# Technical News Bulletin

Steinhausen, 2001

- NNPB Plunger Positioners with Split Ring Attachment**
- With these new positioners, a Plunger Split Ring Attachment is now available as an optional plunger mounting method.
  - Same mold equipment for the new positioners as used for the superseded positioner and requires no modifications.
  - Adjustment range of the new positioners remains identical to that of the previous products.

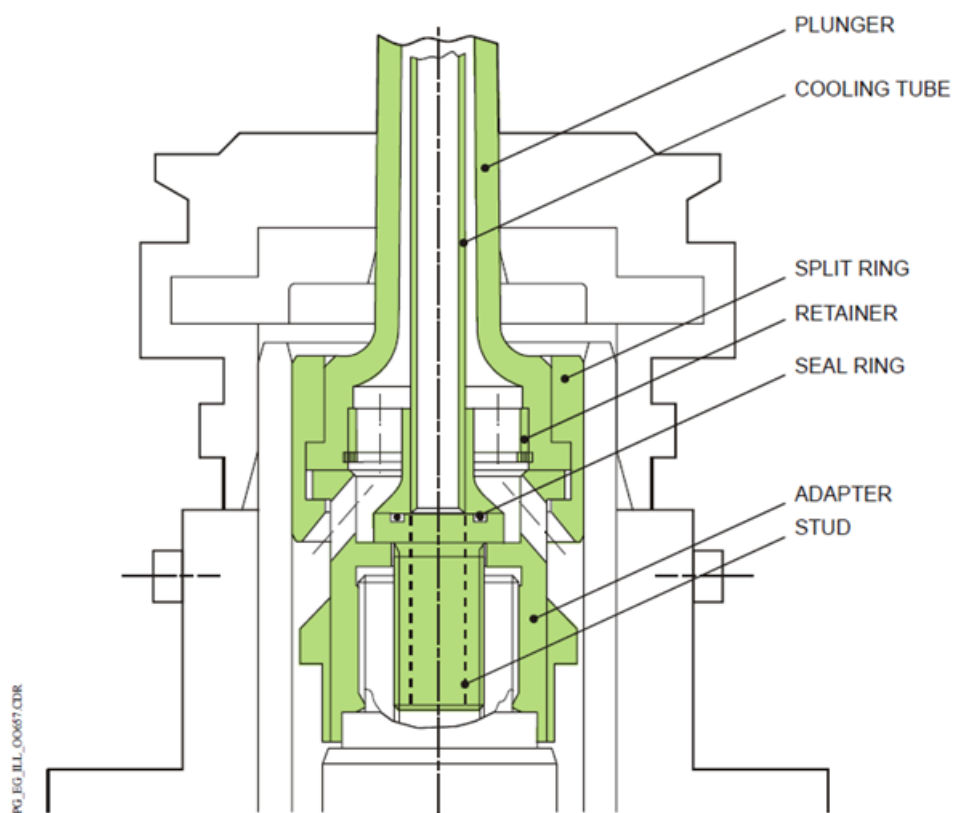
New NNPB Plunger Positioners have been introduced to operate with DG 4 ¼", DG 5", DG 5" Long Stroke, TG 4 ¼" and TG base mounted DG 6 ¼" Quick-Change Plunger Mechanisms to complement the 62-404-9 NNPB Positioner for DG 5 ½" & DG 6 ¼", available since August 1996 (re. TNB 47).

Together with these new positioners, a Plunger Split Ring Attachment is now available as an optional plunger mounting method.

Common to these new positioners is the reduced and standardized plunger "kick back" of 35 mm for optimized plunger loading position and increased plunger length.

The sleeve guide rings are provided with studs to receive a bayonet type retainer to lock the centering sleeve in the DOWN position for plunger exchange when split ring attachment is used.

Hexagon head mounting screws facilitate positioner assembly to or disassembly from the plunger mechanism.
